**DEQ Coal Combustion Residuals
Surface Impoundment
Closure Determination**

Belews Creek Steam Station

April 1, 2019

CROSS SECTION C-C' (VIEWED FROM E SIDE OF BLANKET DRAIN LOOKING WEST)

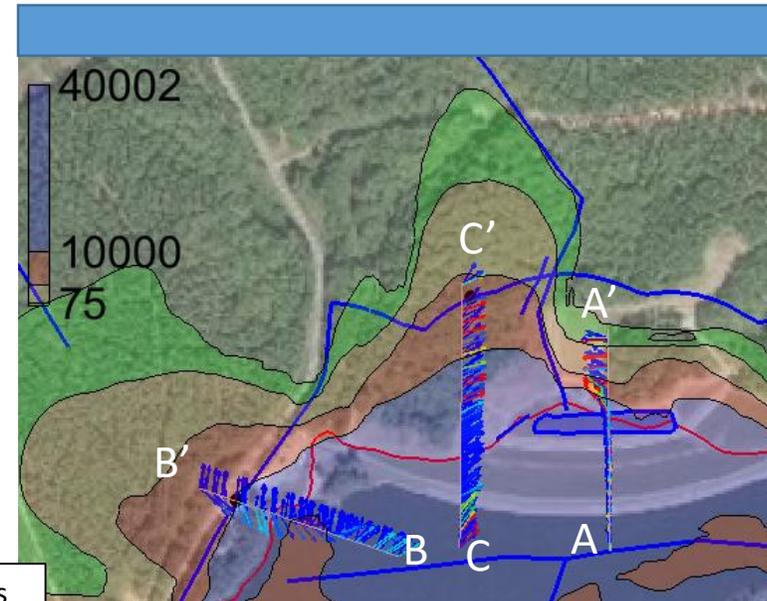
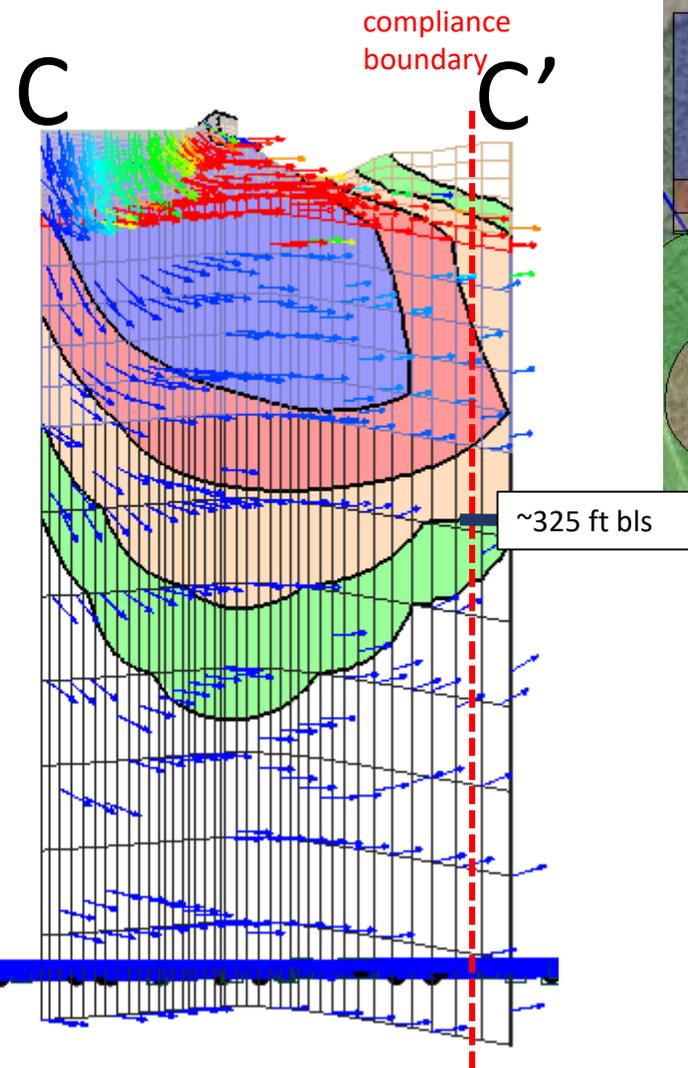
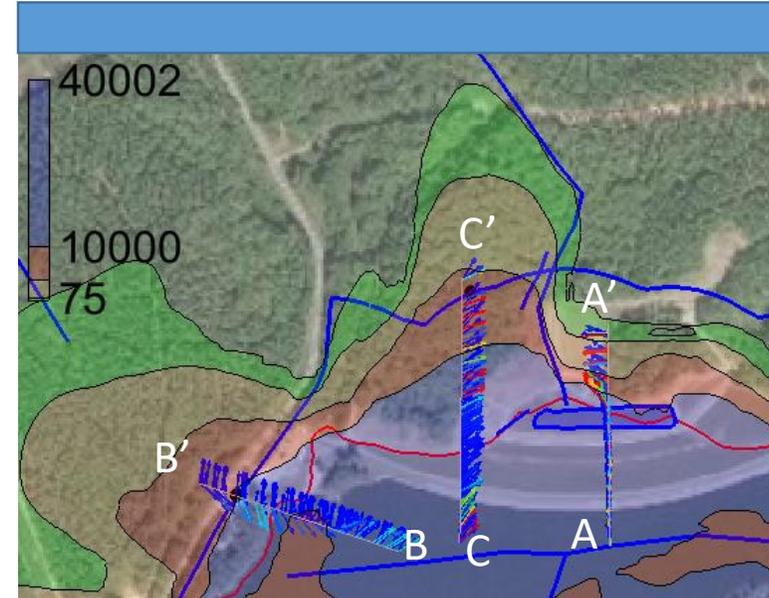
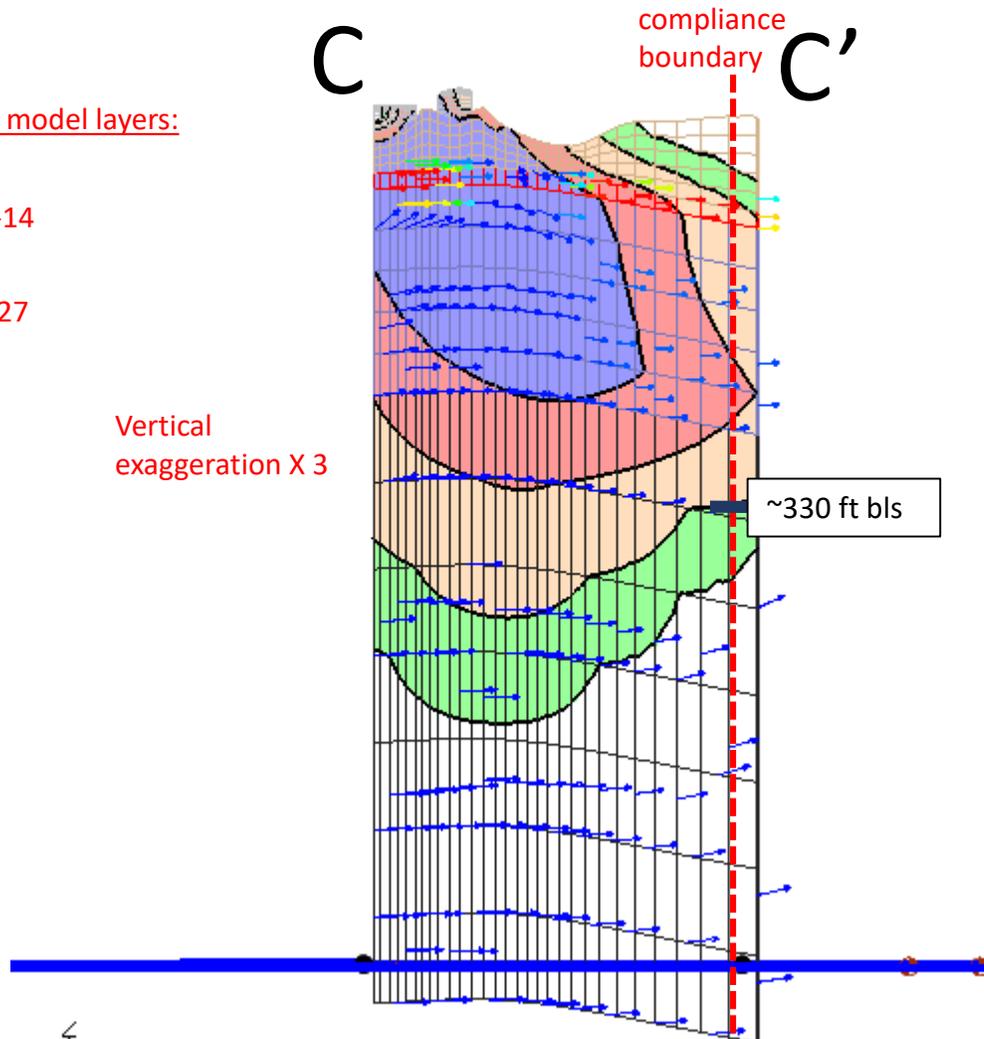
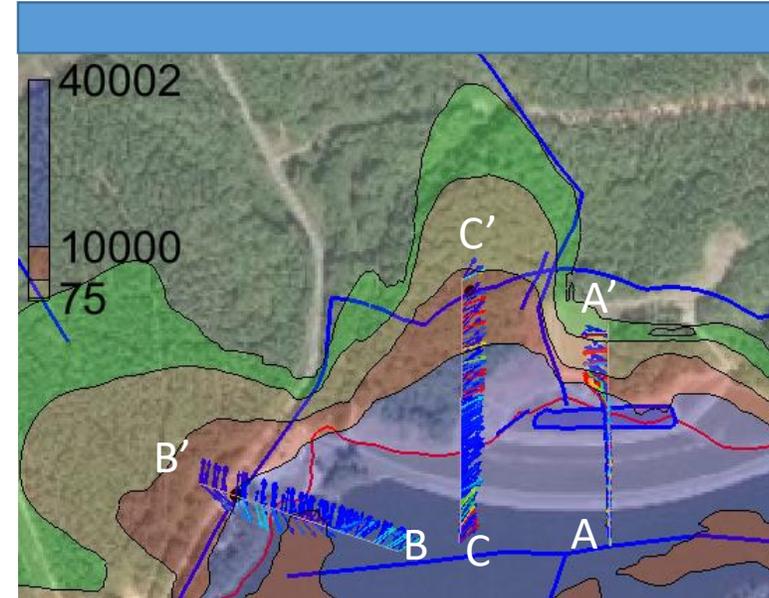
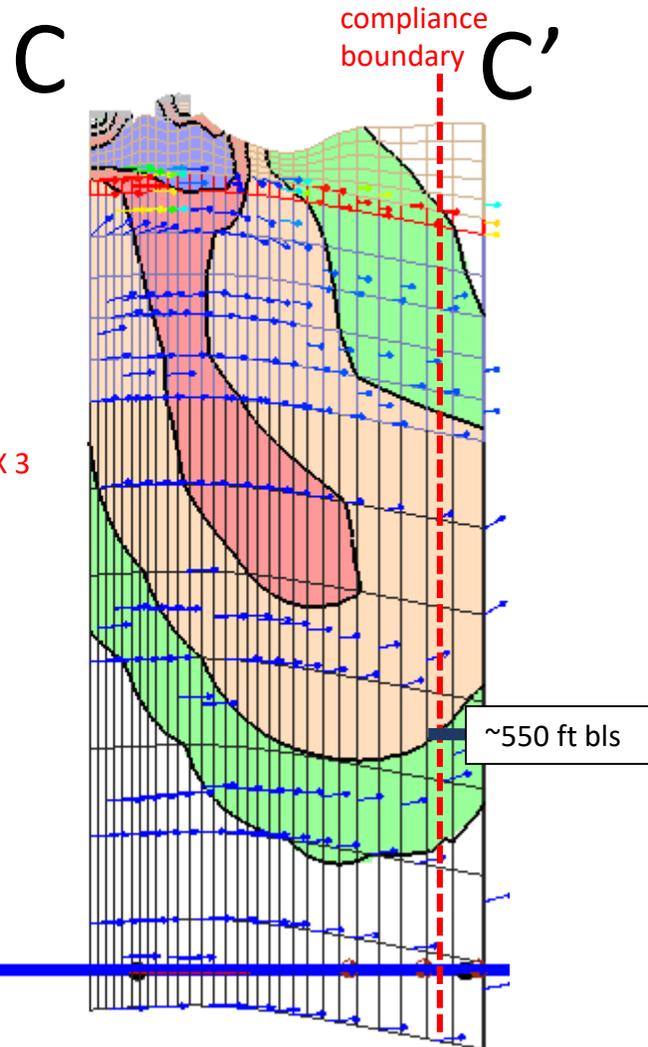
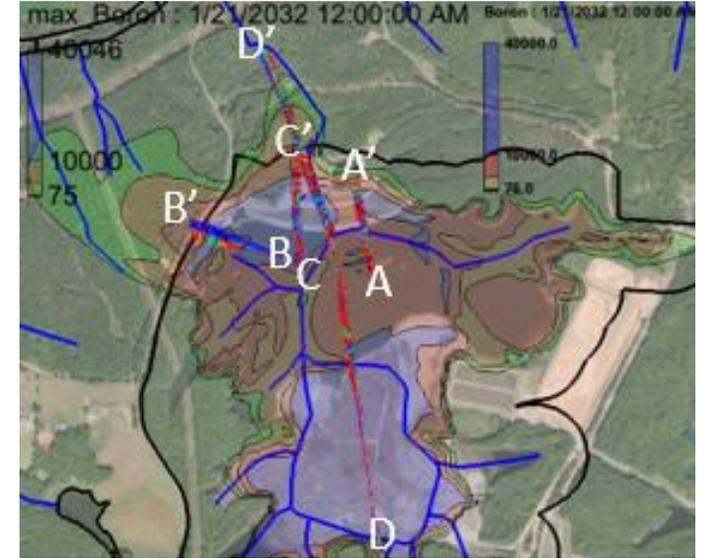
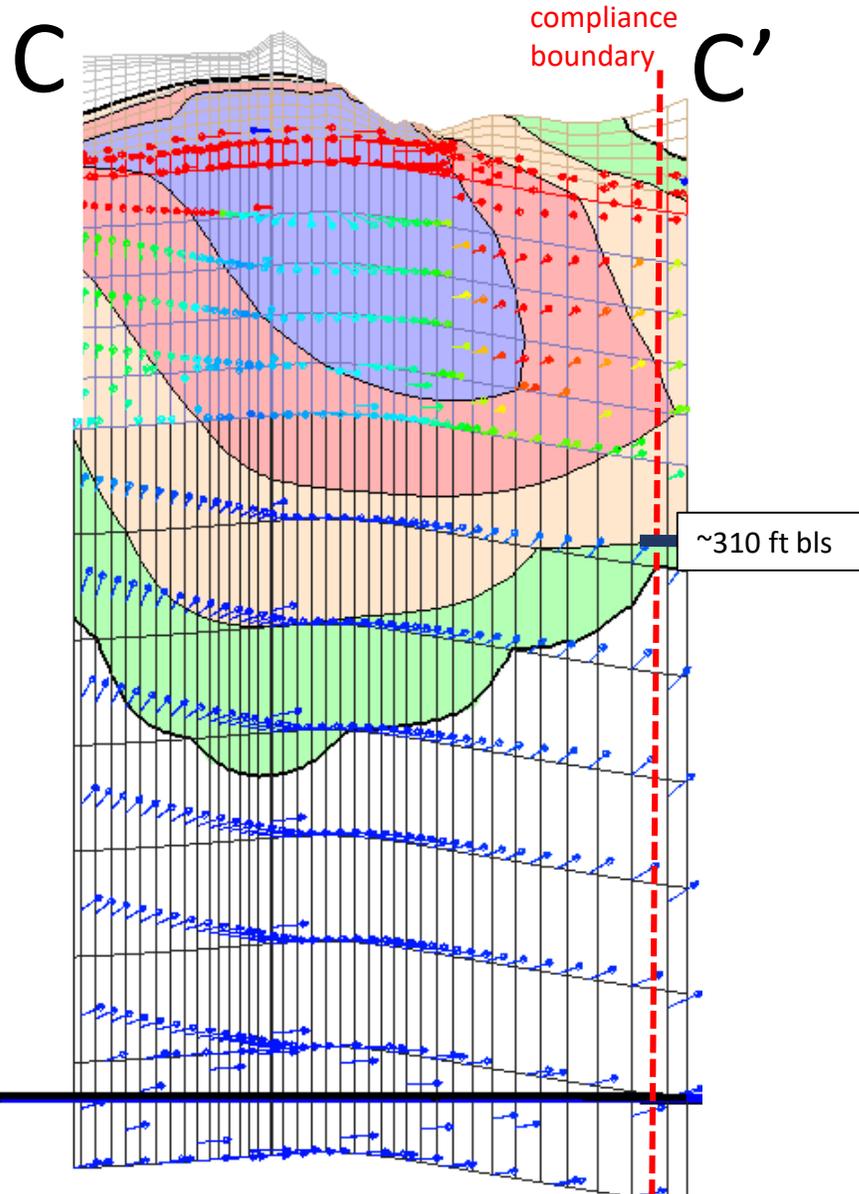
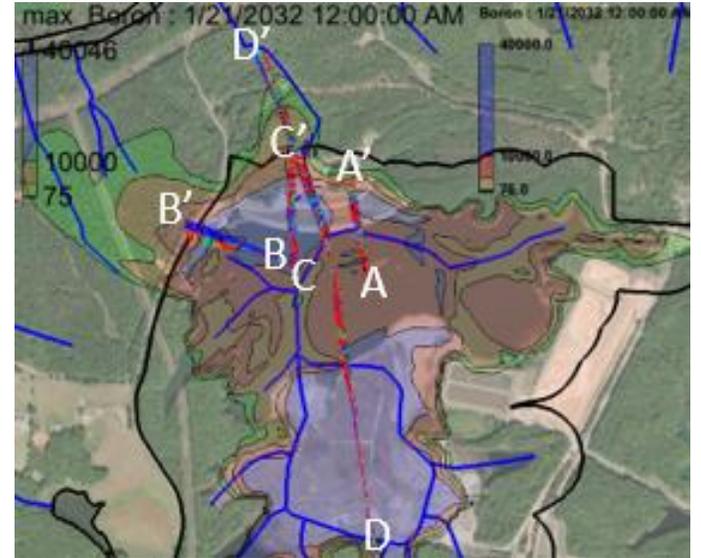
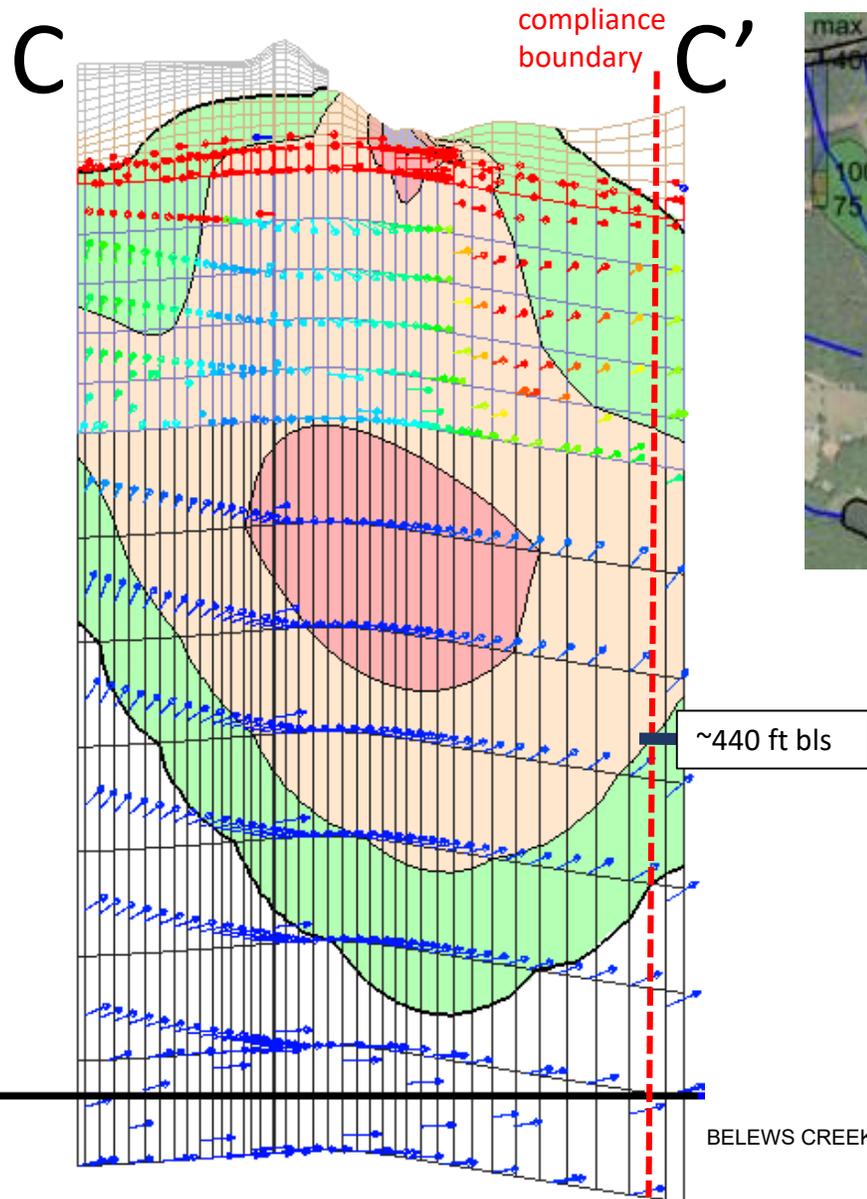
Belews Creek Modeling Results for Cross-Section C-C'			
Model Simulation	Maximum Concentration of Boron Above 2L Beyond Compliance Boundary (ug/L)	Depth of GW Contamination Above 2L Beyond Compliance Boundary (feet bgs)	Width of Contamination Plume Beyond Compliance Boundary (feet)
Current Conditions	4,000-10,000	325	650
Completion of Final Cover (t=0 yrs)	4,000-10,000	330	650
Final Cover (t=125 yrs)	700-4,000	550	700
Completion of Hybrid (t=0 yrs)	4,000-10,000	310	700
Hybrid (t=118 yrs)	700-4,000	440	750

These data illustrate that after completion of closure with the final cover or hybrid option, the groundwater plume still extends beyond the compliance boundary above the 2L groundwater standard and the area of the plume requiring remediation is immense. Even 118 to 125 years beyond completion of closure, the area of the plume requiring remediation remains extensive.
